Submission for Job: #6010 SSD 6010 - One Residential Building (Student Accommodation) within Darling Drive Plot
https://majorprojects.affinitylive.com/?action=view_job&id=6010

SSD 6010 - One Residential Building (Student Accommodation) within Darling Drive Plot

26 July 2013

LEVEL 6

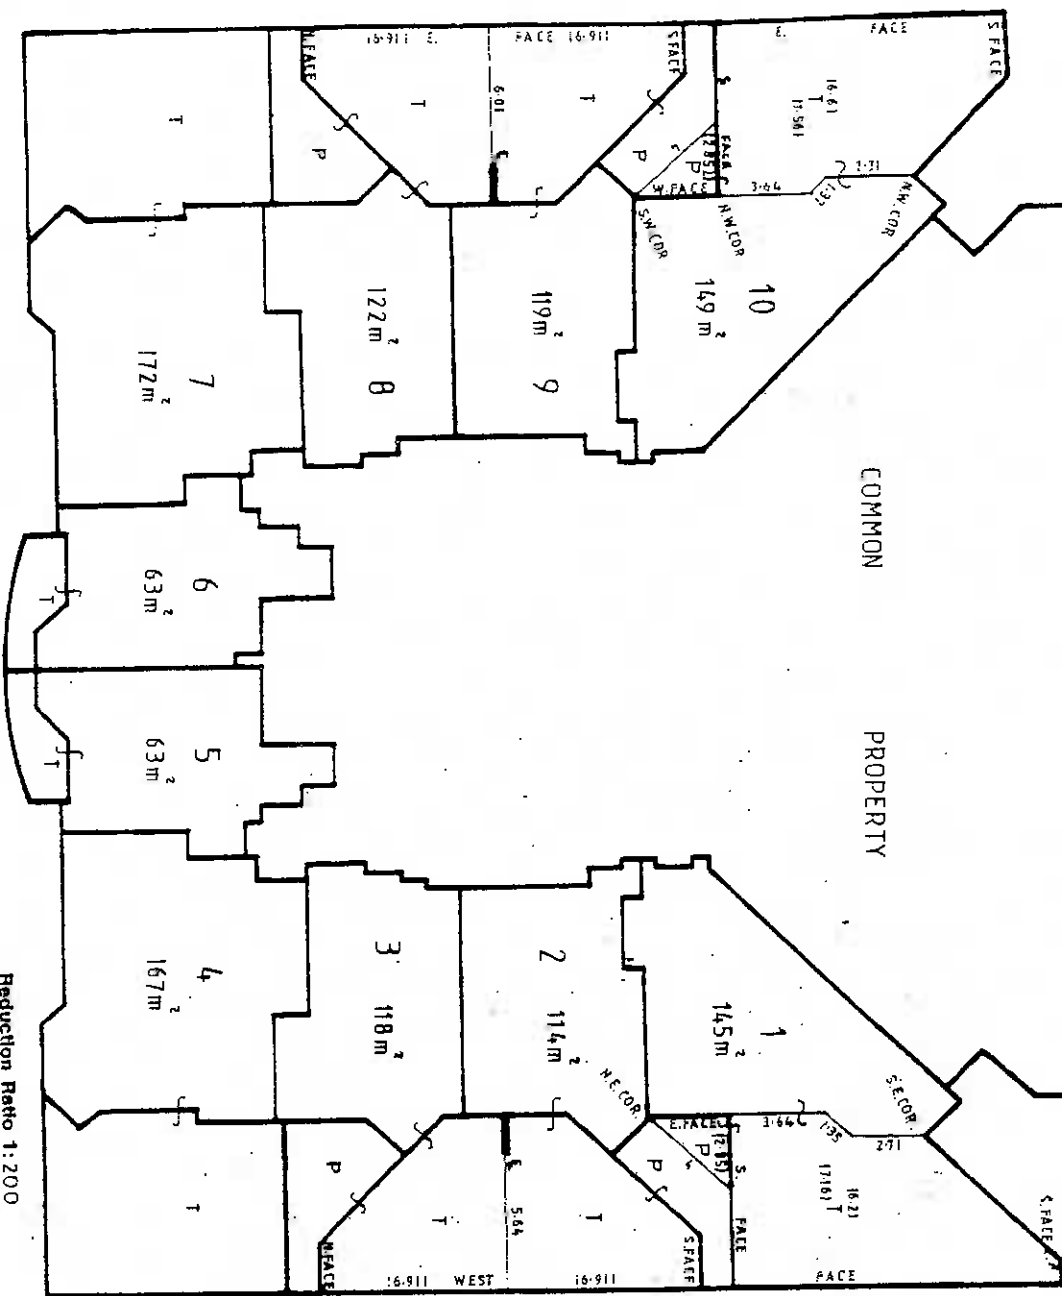
Levels 6 and 7 each contain two apartments with single west aspect , i.e. 4 single aspect apartments.

LEVEL 8

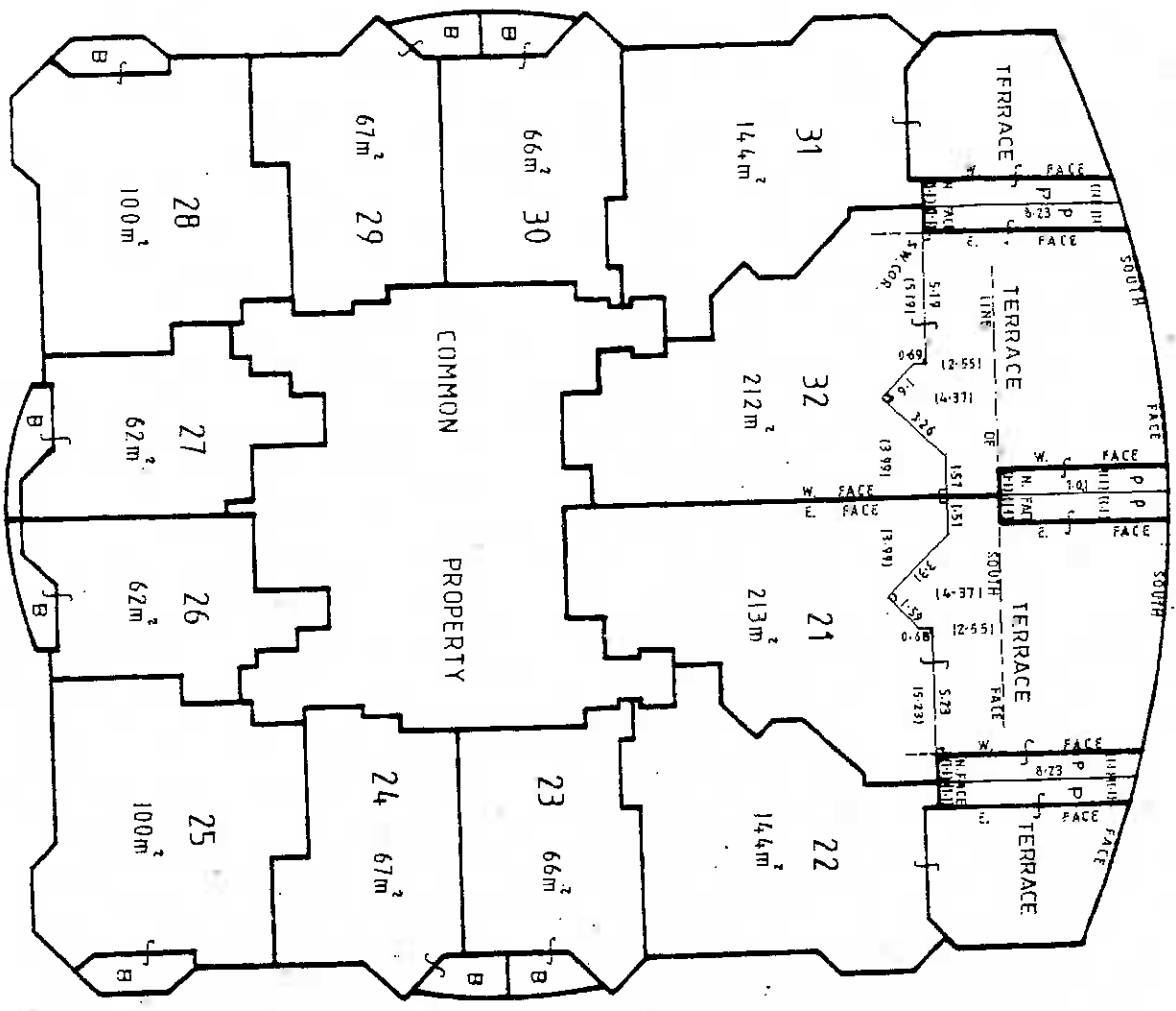
Levels 8-15 each contain two apartments with single west aspect and two apartments with single north aspect , i.e. 4 single aspect apartments per level, giving 32 single aspect apartments.

LEVEL 38

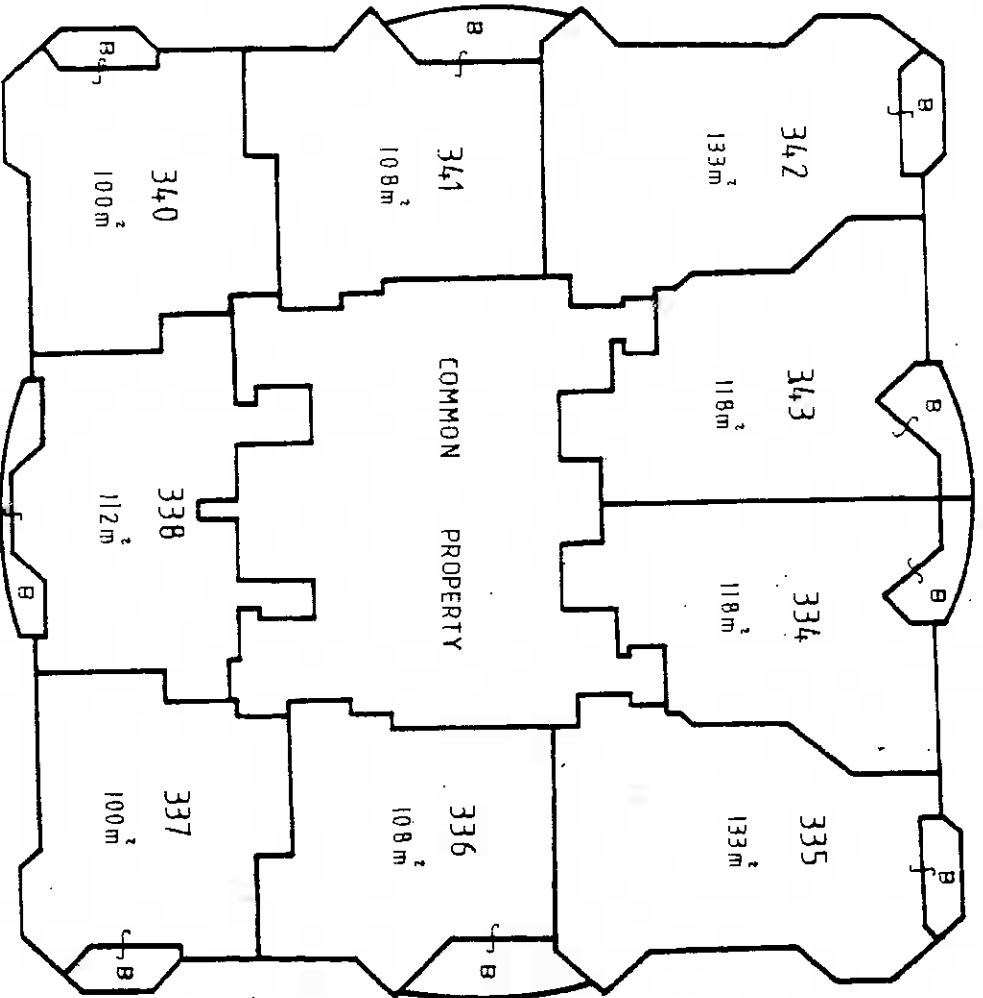
Levels 16-38 each contain one apartment with single west aspect and two apartments with single north aspect, i.e. i.e. 3 single aspect apartments per level , giving 69 single aspect apartments.

LEVEL 39

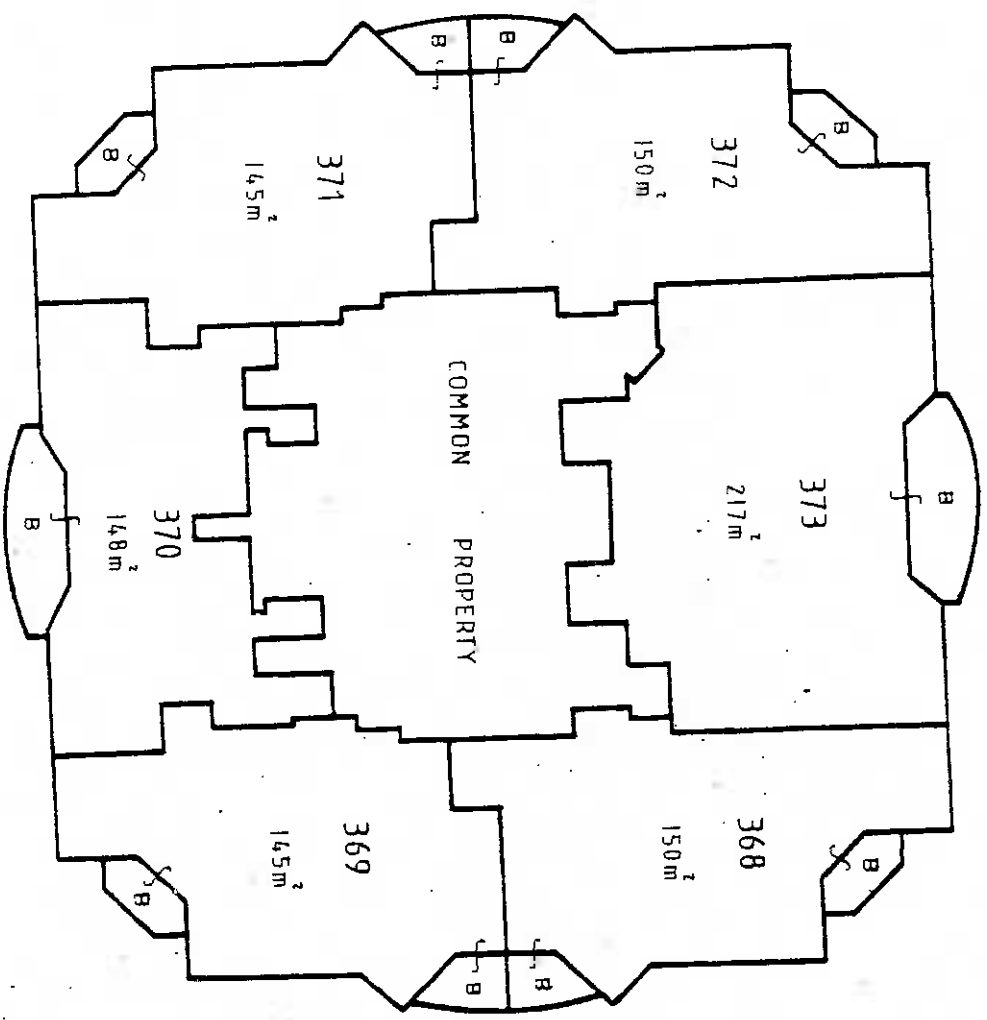
Levels 39-43 each contain one apartment with single north aspect, i.e. 5 single aspect apartments.
